Service Bulletin

Bulletin No. 2007-67
CMD 2007-07

Ground Strap on all Diesel Transoms

- a** - Inner transom plate ground strap location
- b** - Attach to engine or battery ground

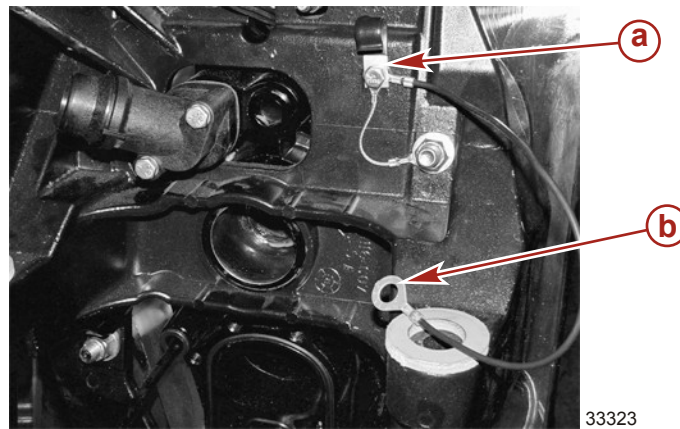
All transoms in the affected serial number range require an additional ground strap between the inner transom plate and the engine ground or battery ground to complete the continuity circuit.

The ground strap is already included in the parts bag for all diesel transoms SN 1A410123 and above. For models affected (above), add a ground strap. Certain applications such as driveshaft extension kits may require a longer strap to complete the ground circuit.

Ground strap (P/N 62826A6) with a length of 33 cm (13 in.). If constructing a new strap, use at least 14 gauge wire and appropriately sized ring eye connectors.
